Proposal #11: 1166-04-84, WISC 2026027
Portage - Coloma
Columbia Co Line to Fawn
Court, Sb
IH 039
Marquette County

This is Addendum No. 01, which provides for the following:

ADDENDUM NO.01

1166-04-84

Addendum No. 01
ID 1166-04-84
Revised Sheet 7
October 6, 2025

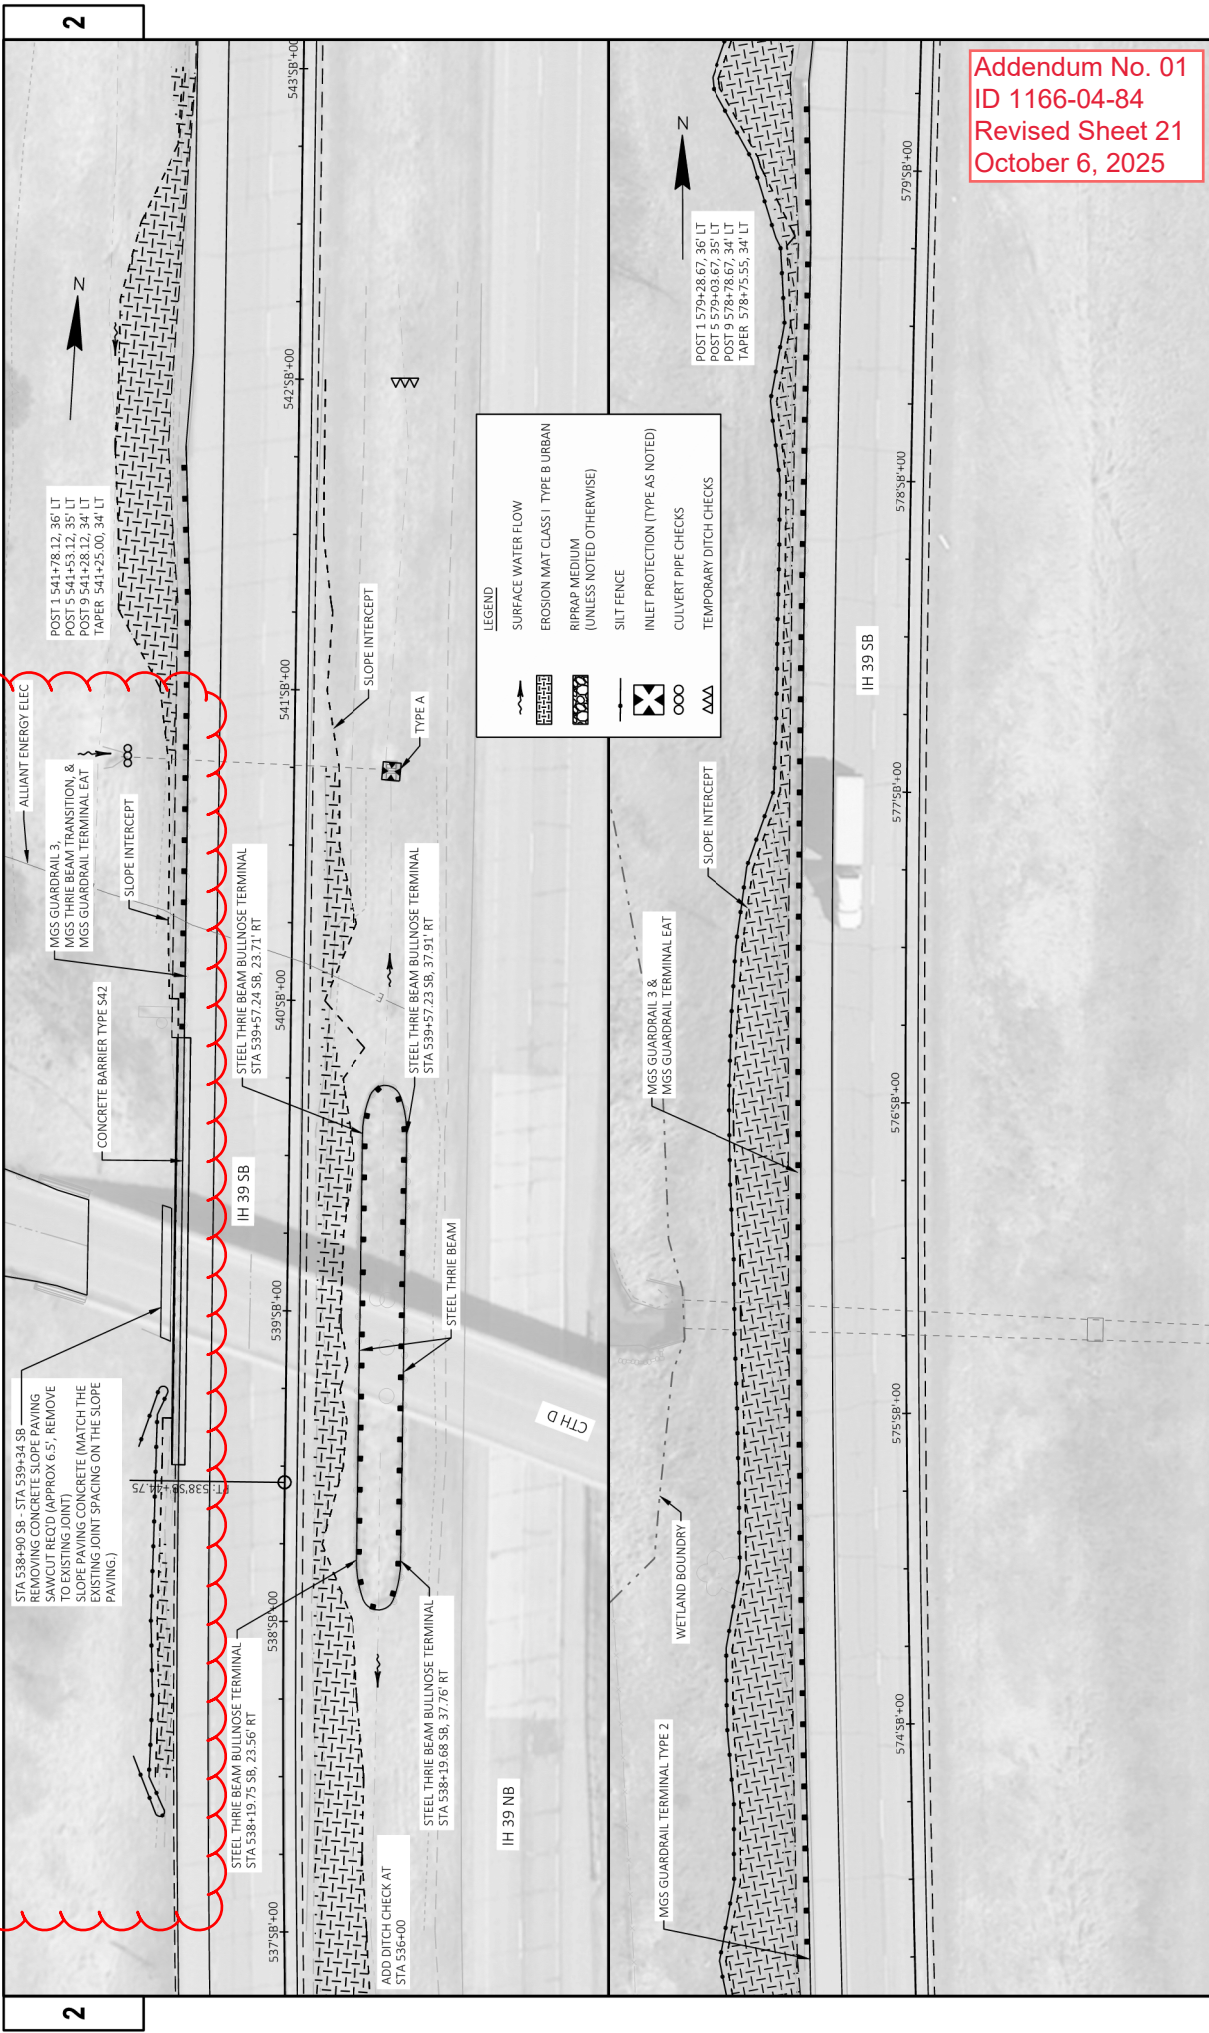
Revised Plan Sheets	
Plan Sheet	Plan Sheet Title (brief description of changes to sheet)
7	Typical Section (added detail for Concrete Barrier and removal and replacing slope paving)
21	Guardrail & Erosion Control (Added notes for Concrete Barrier addition)
72	Miscellaneous Quantities (updated quantities)
77	Miscellaneous Quantities (updated quantities)
82	Miscellaneous Quantities (updated quantities)
294	Cross Section: IH-39 Southbound (updated cross section for Concrete Barrier and Slope Paving)
295	Cross Section: IH-39 Southbound (updated cross section for Concrete Barrier and Slope Paving)

Addendum No. 01
ID 1166-04-84
Added Sheet 295A
October 6, 2025

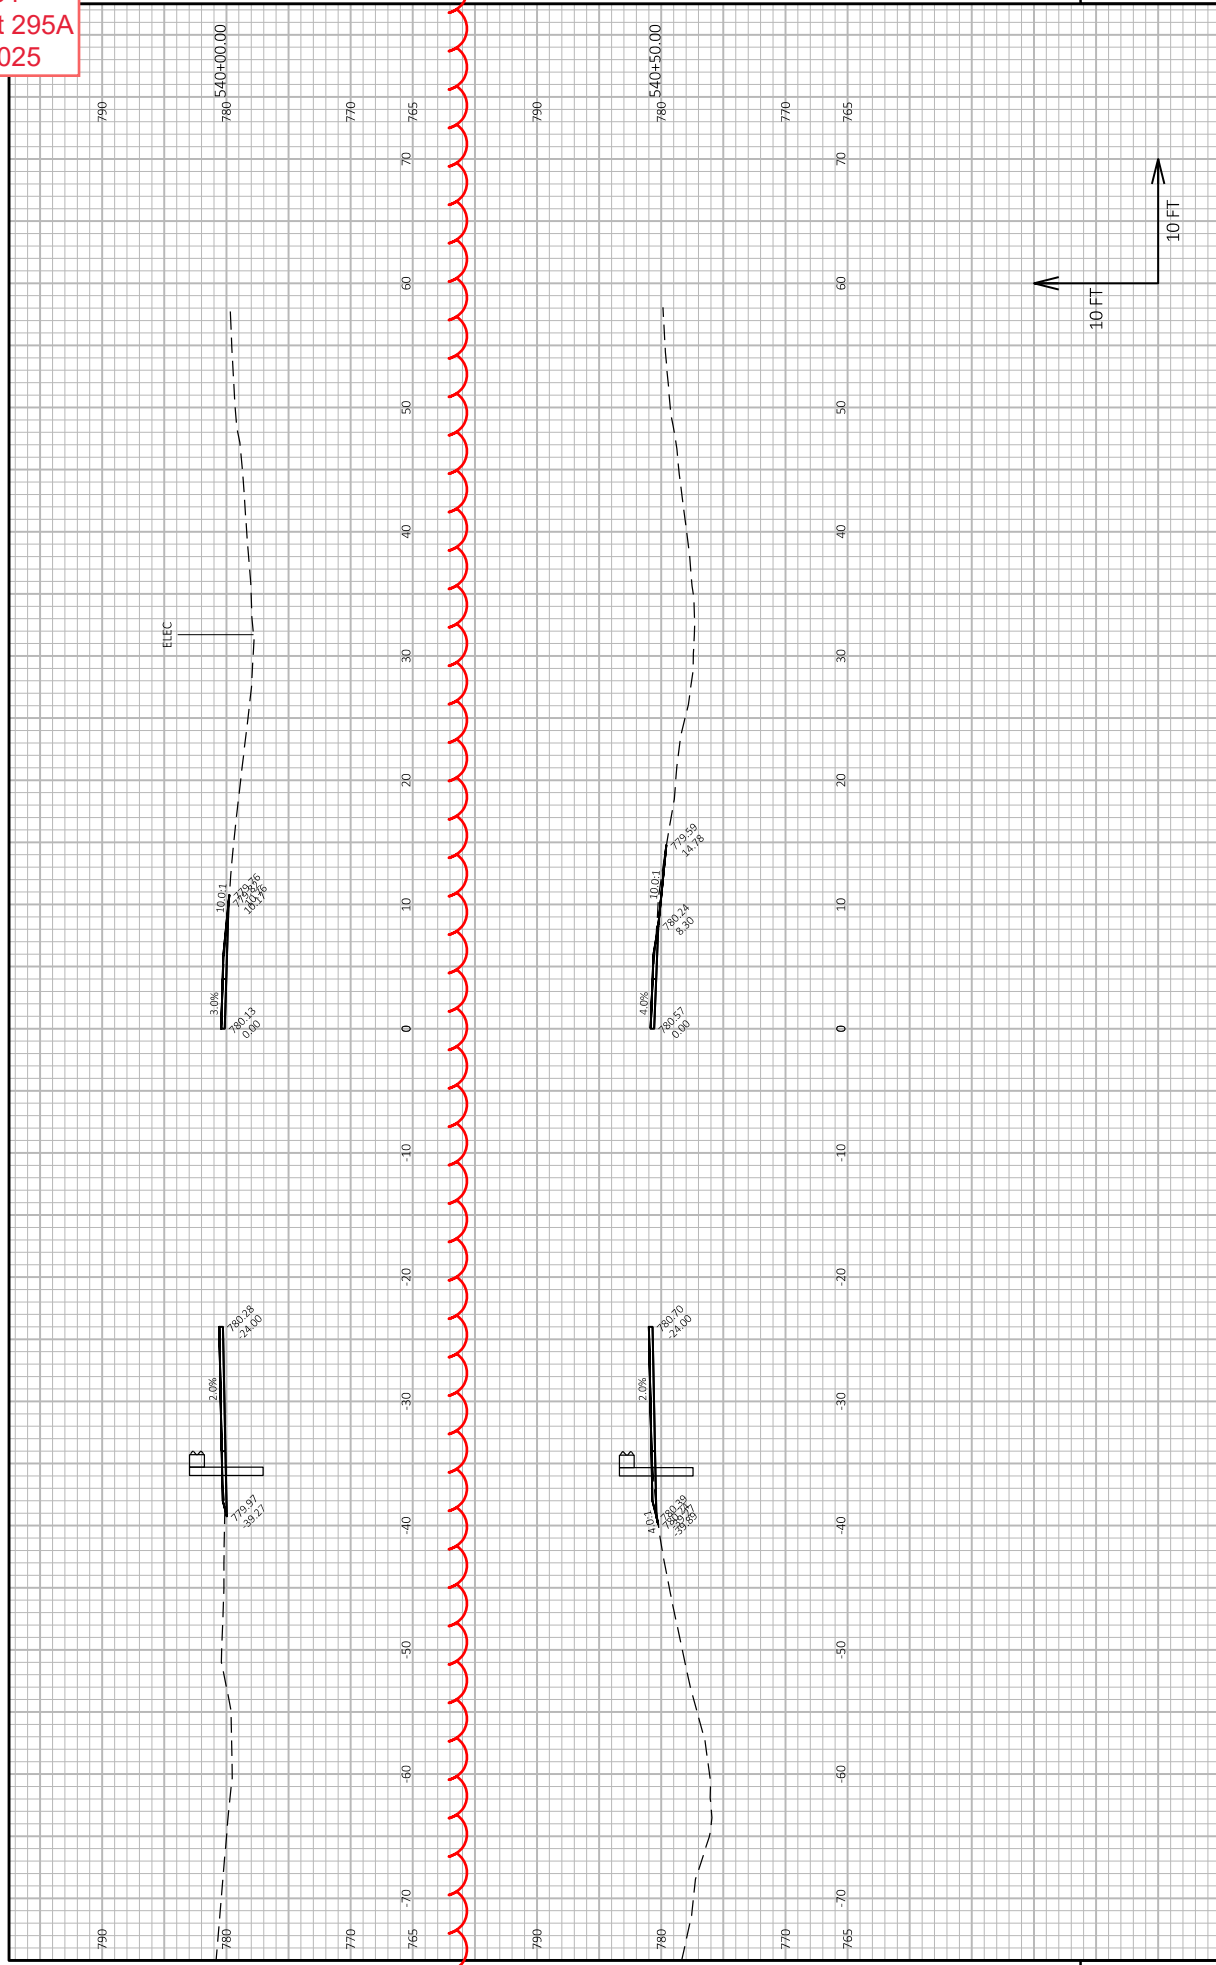
Added Plan Sheets	
Plan Sheet	Plan Sheet Title (brief description of why sheet was added)
123A	SDD 14B20-12H (Added SDD for Thrie beam connection to concrete barrier)
132A	SDD 14B32-11A (Added SDD for Concrete Barrier Single Slope)
132B	SDD 14B32-11B (Added SDD for Concrete Barrier Single Slope)
132C	SDD 14B33-02G (Added SDD for Concrete Barrier Single Slope 42" Thrie Beam Anchor)
132D	SDD 14B33-02H (Added SDD for Concrete Barrier Single Slope 42" Thrie Beam Anchor)
295A	Cross Section: IH-39 Southbound (updated cross section for Concrete Barrier and Slope Paving)
